PALISADES PLANT

AMENDMENT TO PROVISIONAL OPERATING LICENSE

Amendment No. 57
License No. DPR-20

ATTACHMENT TO LICENSE AMENDMENT NO. 57

Figure 3-10

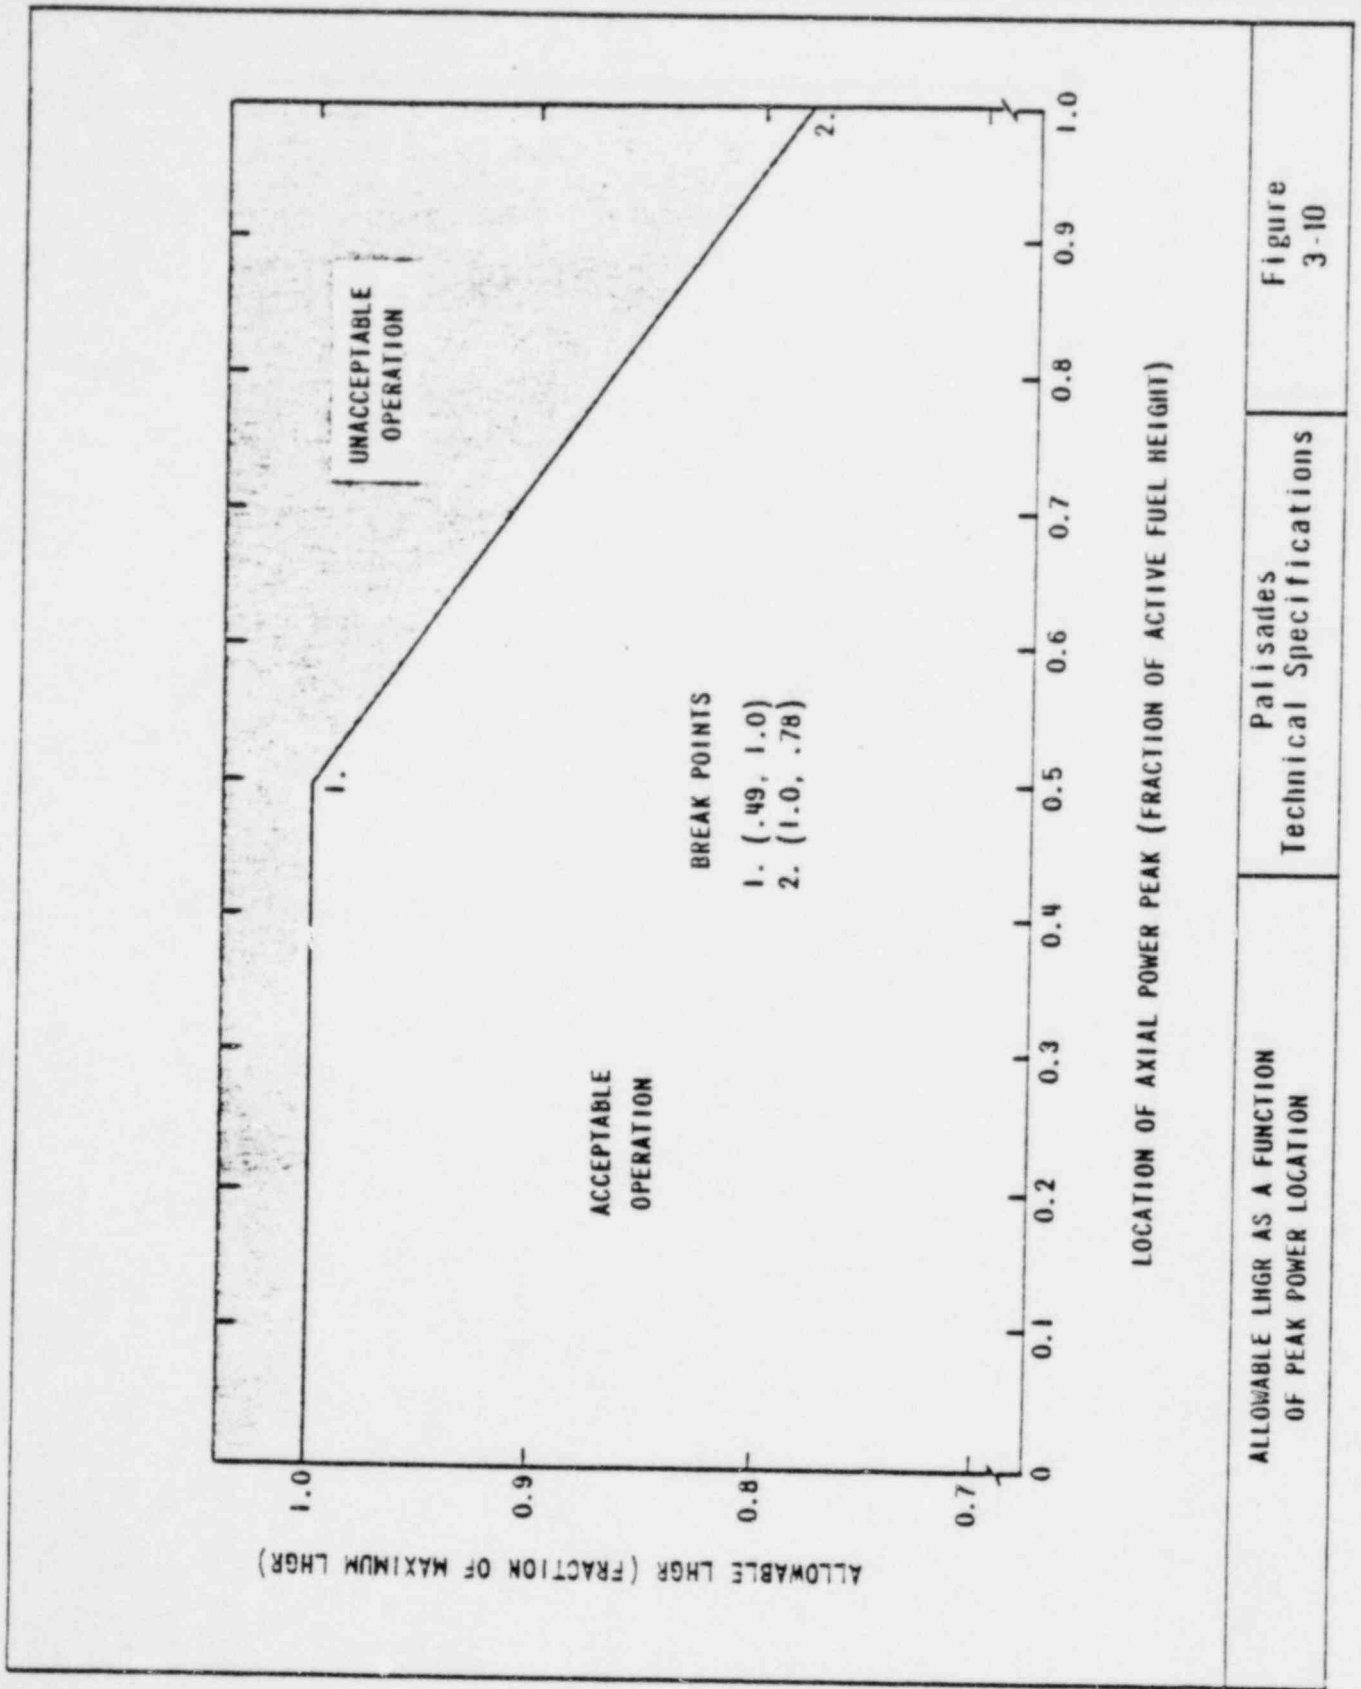
- a. The linear heat generation rate at the peak power Elevation Z shall not exceed $15.28 \text{ kW/Ft} \times F_A(Z)$, and the linear heat generation rate in any interior fuel rod at the peak power elevation shall not exceed $14.33 \text{ kW/Ft} \times F_B(Z)$ where the function $F_A(Z)$ is shown in Figure 3.9 and $F_B(Z)$ is shown in Figure 3.10. If the power distribution is double peaked, both peaks shall
